Item Name: Crosstube Turning Detail

DART AEROSPACE LTD	Work Order: 116472
Description: Crosstube Assembly (206L High Fwd)	Part Number: D206-667-143
Inspection Dwg: D206-667-143 Rev: C	Page 1 of 2

TITLE
CROSSTUBE ASS'Y (206L HIGH FWD)

DRAWING NO. D206-667-143	TITLE CROSSTUBE ASS'Y (206L HIGH FWD)	REV. C	DART AEROSPACE LTD ENGINEERING ORDER		D.E.O. NO. D206-667-143-C-1	SHEET NO. SHEET 1 OF 1	SCALE NTS
DRAWN 9	CHECKED ASS	MFG. APPR. [Signature]	APPROVED [Signature]		DE APPR. [Signature]		
DATE 11.07.15	DATE 11.07.20	DATE 11.07.21	DATE 11/07/21		DATE 11.07.21

DETAIL P
BONDING STRAP INSTALLATION 2 PL

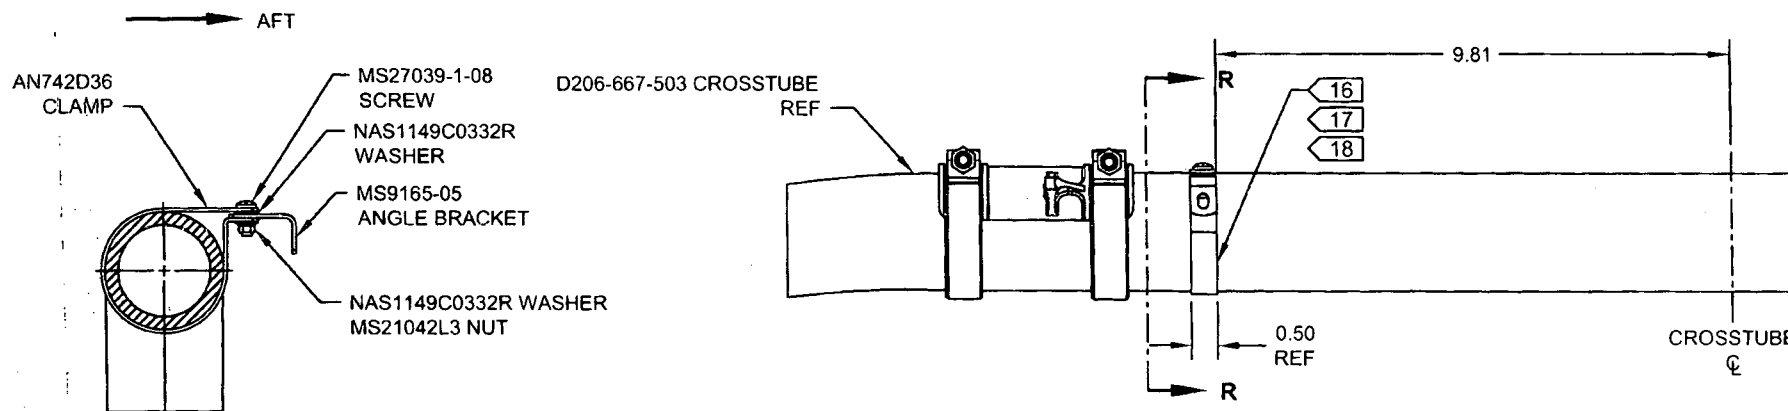
ADD ELECTRICAL GROUNDING STRAP

ITEM	QTY -143	PART NUMBER	DESCRIPTION
1	X	D206-667-143	CROSSTUBE ASSEMBLY (206L HIGH FWD)
<i>[Lightning Bolt Symbol]</i>			
10	2	AN742D36	CLAMP
11	2	MS9165-05	ANGLE BRACKET
12	2	MS21042L3	NUT (OR MS21042-3)
13	2	MS27039-1-08	SCREW
14	4	NAS1149C0332R	WASHER (OR AN960C10L)

- 16) MASK AREA UNDER CLAMP PRIOR TO PAINTING
- 17) SEAL EDGES WHERE AN742D36 CLAMP MEETS WITH THE CROSSTUBE USING SIKAFLEX-241/-291 OR MIL-S-8802 CLASS B2 OR PROSEAL 890 SEALANT
- 18) PERFORM RESISTANCE CHECK TO ENSURE MAX RESISTANCE IS 10 MILLIOHMS
